# SECTION 00900 | ADDENDUM TO BIDDING REQUIREMENTS

## ADDENDUM # 4

Project Name: *P22-HRBR-01 (EDA Madison Harbor Terminal Improvements)*

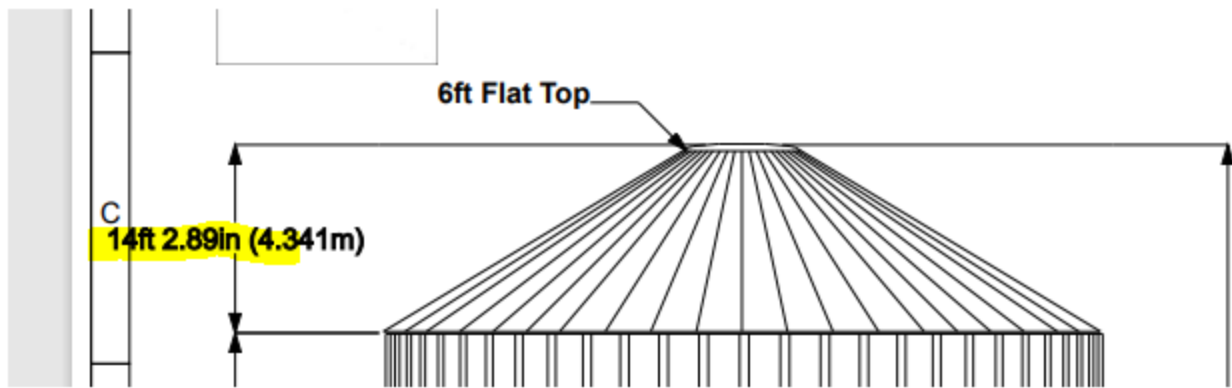
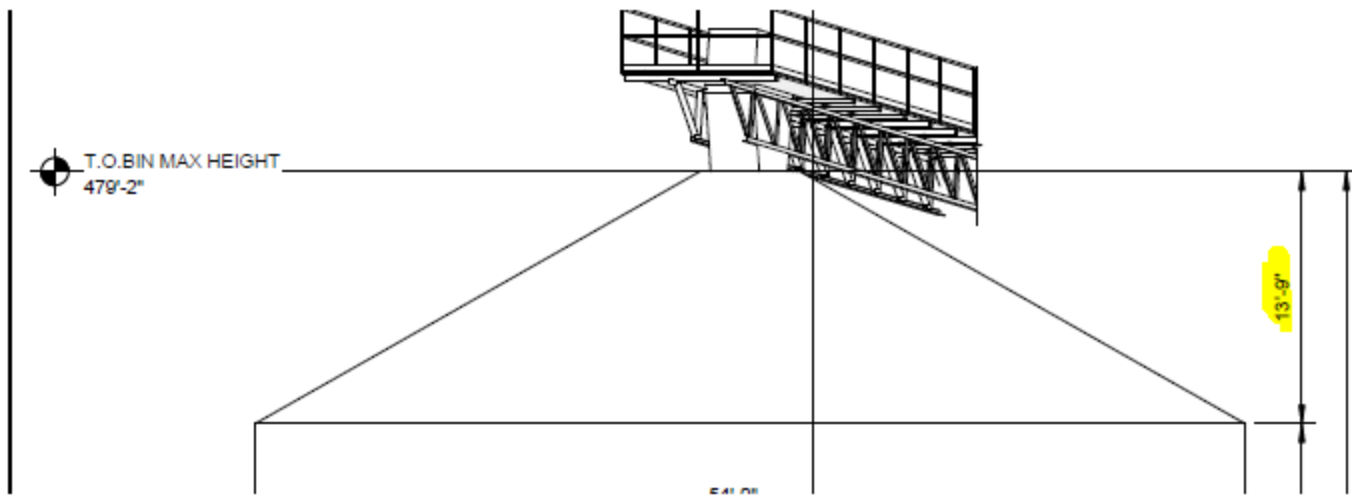
ITEM	DESCRIPTION
1.	<p>It looks like they wanted the roof to stay under 13' 9" and ours would be a few inches over 14' as seen below. And then they wanted to sidewall height to remain under 44'1" so I had to reduce my original bin by two rings, therefore it decreased the level bushel capacity to 82k, however, the peak bushel capacity still meets their ask with 91k.</p> <p><b>Response:</b> The capacity of the bin is required to be 90,000 bushels; it is up to the vendor/supplier to accommodate this requirement within the confines of their bin design.</p> <p>The heights and dimensions supplied on the drawings outline an envelope that the supplied equipment must fit within.</p>

3 BIN FOUNDATION SECTION  
 1/4" = 1'-0"

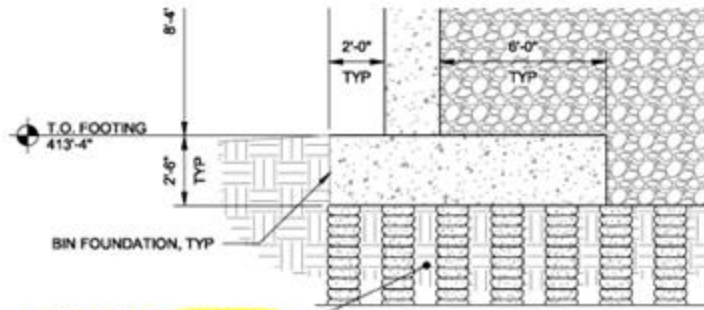
2.	<p>Regarding Drawing Sheet S302 call outs "Remove organics and fill down to undisturbed soil. Backfill with Structural Fill Per Specifications S12000 Prior to Installation of Aggregate Piers".</p> <p>1.Specification does not contain info about removal/replacement of any unsuitable soils. The nearest boring to our work location for new bin footing appears to be B-15 taken in the July 2014 Geotech report by QTI. Bore B-15 does not indicate any fill material in this location. Is the intent of this note only to remove +/- 4" of topsoil? If over-excavation and backfill with suitable soils is required please indicate the limits and to what depths of replacements are required.</p> <p><b>Response:</b> Base bid should assume 2'-6" of top soil and granular fill excavation to accommodate the new foundation slab bottom elevation as shown in 3/S302.</p>

REMOVE ALL ORGANICS AND  
 FILL DOWN TO UNDISTURBED  
 SOIL. BACKFILL WITH  
 STRUCTURAL FILL PER  
 SPECIFICATION 312000  
 PRIOR TO INSTALLATION OF  
 AGGREGATE PIERS
